**ZONING AMENDMENT,  
PLANNED UNIT DEVELOPMENT &  
SUBDIVISION STAFF REPORT**

**Date: September 17, 2015**

<b><u>NAME</u></b>	Zimmer Development Company
<b><u>SUBDIVISION NAME</u></b>	Campus Crest Subdivision
<b><u>LOCATION</u></b>	139 East Drive (East side of East Drive extending to the West side of Long Road (not open), 90'± North of Windham Court)
<b><u>CITY COUNCIL DISTRICT</u></b>	District 6
<b><u>PRESENT ZONING</u></b>	R-3, Multiple-Family Residential District
<b><u>PROPOSED ZONING</u></b>	R-3, Multiple-Family Residential District
<b><u>REASON FOR REZONING</u></b>	To remove conditions of previous zoning approvals.
<b><u>AREA OF PROPERTY</u></b>	1 Lot / 10.6 ± Acres
<b><u>CONTEMPLATED USE</u></b>	<p>Subdivision approval to create 1 lot, Planned Unit Development approval to allow multiple buildings on a single building site, and Rezoning from R-3, Multiple-Family Residential to R-3, Multiple-Family Residential, to remove conditions of previous zoning approvals, to allow an apartment complex.</p> <p><b>It should be noted, however, that any use permitted in the proposed district would be allowed at this location if the zoning is changed. Furthermore, the Planning Commission may

# EXISTING SITE PLAN

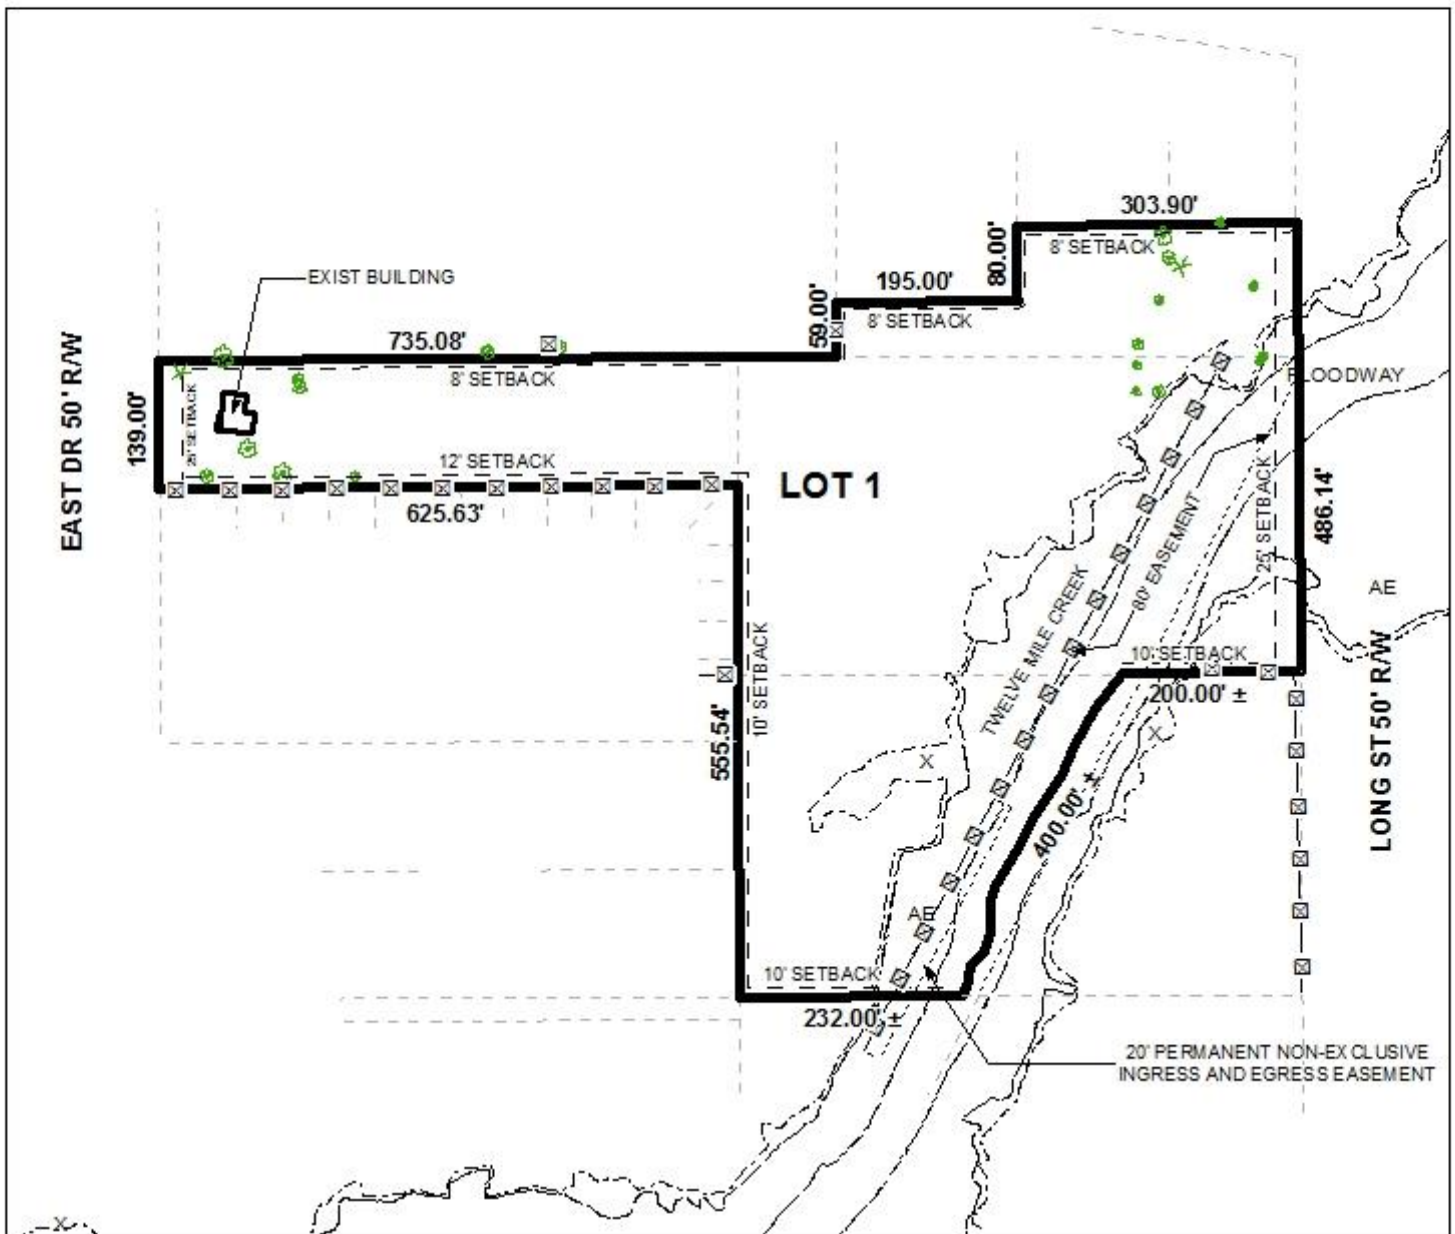
- B. Add Long Street ROW to the drawing.
- C. Provide a written legal description for the proposed subdivision and matching bearing and distance labels.

- D. Show and label the MFFE (Minimum Finished Floor Elevation) on each lot that contains an AE, V, or X (shaded) flood zone designation.
- E. Provide the Surveyor's, Owner's (notarized), Planning Commission, and Traffic Engineering signatures.

The 25-foot minimum building setback is not shown on the preliminary plat along Long Street, but it is depicted for East Drive. The setback is shown for both streets on the PUD site plan. The plat should be revised to show the minimum building setback along all abutting rights-of-way.

- 1) Revision of the plat to depict a 25-foot setback along all abutting street frontages.

# PROPOSED SITE PLAN

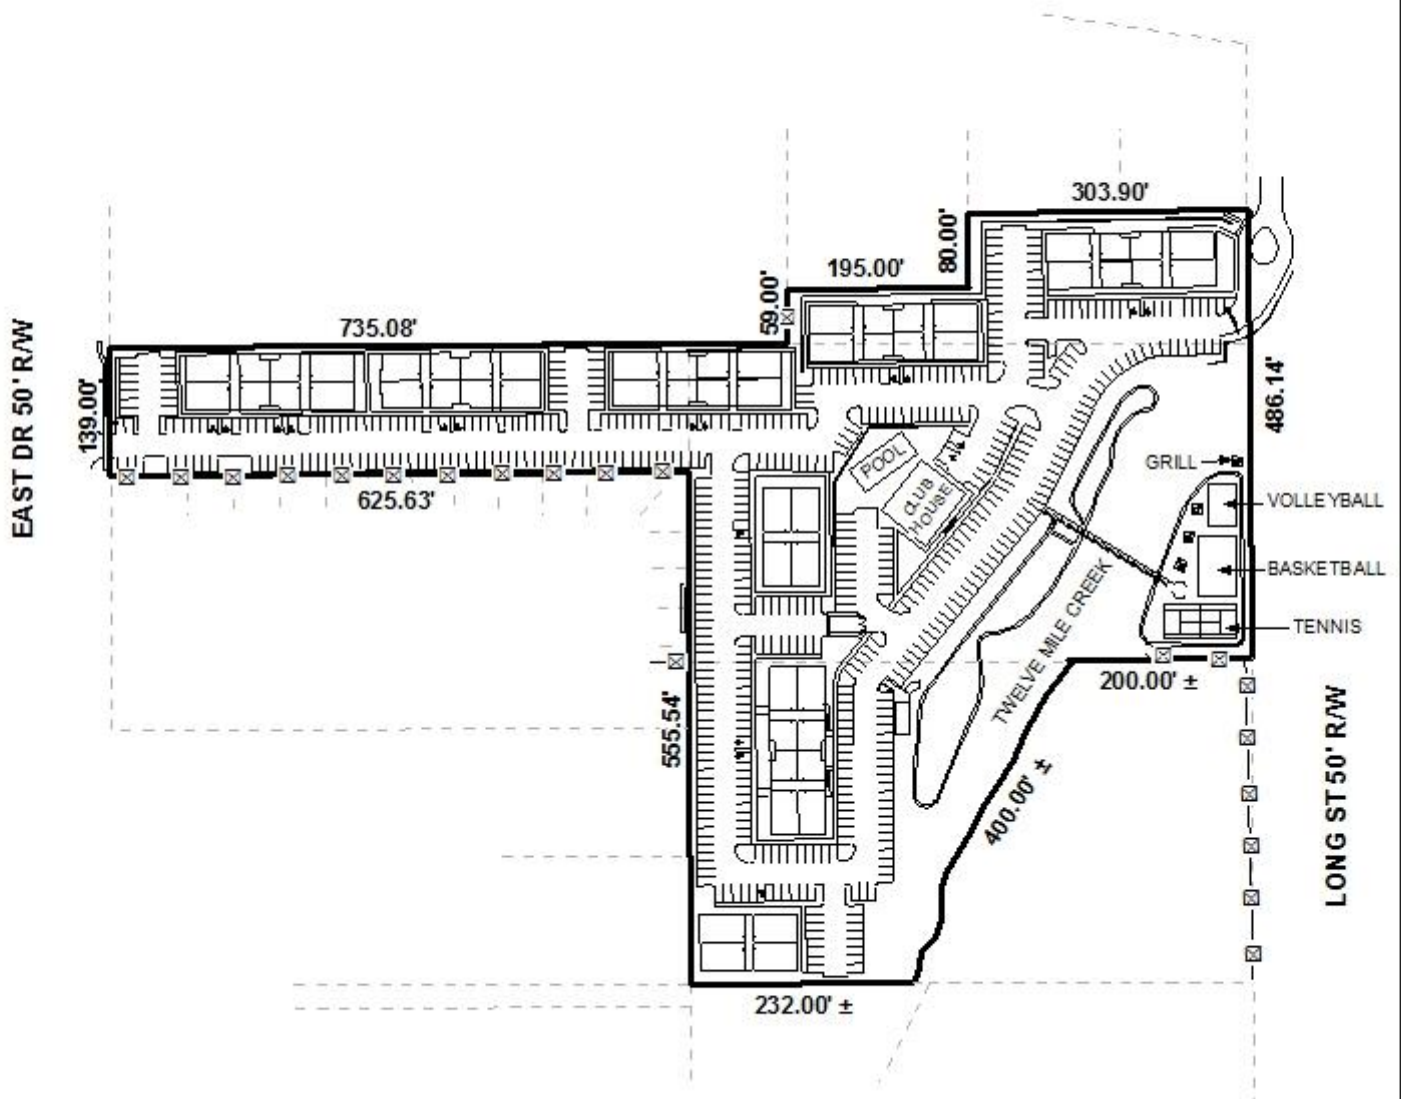
The applicant proposes to develop a 168 unit, 516 bed apartment complex with 567 parking spaces. The apartments will be in 8 three-story buildings, and there will be a separate club house with pool, a maintenance building, and tennis, volleyball and basketball courts. The recreational courts will be located via pedestrian bridge on the East side of Twelve Mile Creek. Vehicular, gated access for residents and guests will be from Long Street, while an “*emergency vehicle only*” gated access point will be provided on East Drive.

The site is located within the area impacted by the amended multi-family parking requirements adopted by the City Council earlier in 2015. The amendment requires “One (1) space per bedroom plus 10% of the total amount of spaces” for the development, which staff calculates to be  $516 \times 1.1 = 567.6$  or 568 parking spaces required. It appears that the site is 1 parking space short of the total required.

One dumpster is depicted on the site plan. The dumpster and enclosure must comply with Section 64-4.D.9. of the Zoning Ordinance.

The site abuts single-family residences. A minimum 6-foot high wooden privacy fence should be provided where the site abuts single-family residences. The fence should be no taller than 3-feet where it is within the 25-foot setback from the improved portions of Long Street or East Drive.

It is assumed that the primary residents of the proposed complex will be students attending the nearby University of South Alabama. For this reason, it is recommended that a pedestrian gate be provided at both the Long Street and the East Drive frontages. A sidewalk is depicted as being provided along East Drive, and such should also be depicted and provided for the frontage on the improved portion of Long Street.

- 1) Submission of two copies of a Traffic Impact Study;
- 2) Revision of the site plan to depict 568 parking spaces;
- 3) Revision of the site plan to depict and label an “emergency vehicle only” access gate on East Drive, and a pedestrian gate;
- 4) Revision of the site plan to depict a 6-foot high wooden privacy fence (3-feet high in the 25-foot setback) where the site abuts single-family residences;
- 5) Revision of the site plan to depict and label any other perimeter fencing, and a pedestrian gate at the Long Street entrance; and
- 6) Revision of the site plan to depict a sidewalk on the to-be improved segment of Long Street.

- 1) Vehicular access to East Drive to be gated and limited to emergency vehicles only;
- 2) Compliance with Engineering comments (*1. Label the Minimum Finished Floor Elevation (MFFE) for each lot. ADD THE FOLLOWING NOTES TO THE PUD SITE PLAN: 1. The applicant shall extend Long Street to the south to provide access to this site. The roadway shall be approved, constructed and accepted in accordance with Engineering Department requirements prior to issuance of any Certificate of Occupancy.);*

- 6) *Provision of a photometric plan at time of application for land disturbance;*
- 7) *Provision of a revised PUD site plan prior to the signing of the Final Plat; and*
